# Access Compliance Report

## Public Rights-of-Way

Intersection ID: 3740	Main Street: CHESTNUT_KNOLL_LN	Cross Street: DAVIS_LAKE_PY	Location: W
ADA ID: BE87098B3181	Ramp Type: Perp	Initial Pass/Fail: Fail	Overall Compliance: No
Severity Score: 26.25			
Codes/Mitigation Info/Possible Solution		Field Measurements/Component Compliance

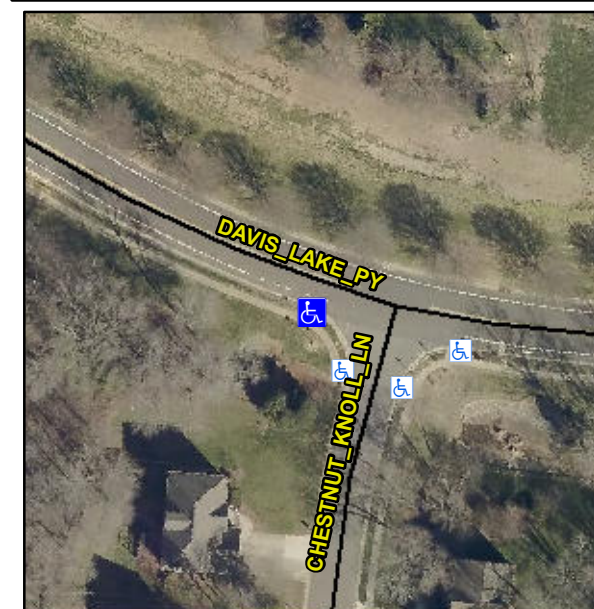
**Not Found, R304.2.2, R304.5.3**

Compliance	Description	Data	Compliance	Description	Data
N/A	Ramp Length (in)	48.0	No	Ramp Slope (%)	18.5
Yes	Ramp Width (in)	48.0	No	Ramp XSlope (%)	2.5
N/A	Flare Type LT	N/A	N/A	Flare Type RT	N/A
N/A	Flare Slope LT (%)	N/A	N/A	Flare Slope RT (%)	N/A
N/A	Flare Traversable LT?	N/A	N/A	Flare Traversable RT?	N/A
N/A	Landing Length (in)	N/A	N/A	DWS Provided?	N/A
N/A	Landing Width (in)	N/A	N/A	DWS Contrast?	N/A
N/A	Landing Slope (%)	N/A	N/A	DWS Length (in)	N/A
N/A	Landing X Slope (%)	N/A	N/A	DWS Full Width?	N/A
N/A	Landing Curb? (Y/N)	N/A	N/A	DWS Offset (in)	N/A
N/A	Shared Landing?	N/A			
N/A	Gutter Ponding?	N/A	N/A	Gutter Slope (%)	N/A
N/A	Gutter Lip Ht (in)	N/A	N/A	Gutter X Slope (%)	N/A
N/A	Painted X Walk1?	No	N/A	Painted X Walk2?	N/A
	X Walk 1 Direction	To NE		X Walk 2 Direction	N/A
N/A	X Walk 1 Width (in)	N/A	N/A	X Walk 2 Width (in)	N/A
	X Walk 1 Slope (%)	4.6		X Walk 2 Slope (%)	N/A
	X Walk 1 X Slope (%)	0.1		X Walk 2 X Slope (%)	N/A

**Remove & Replace Entire Ramp.**
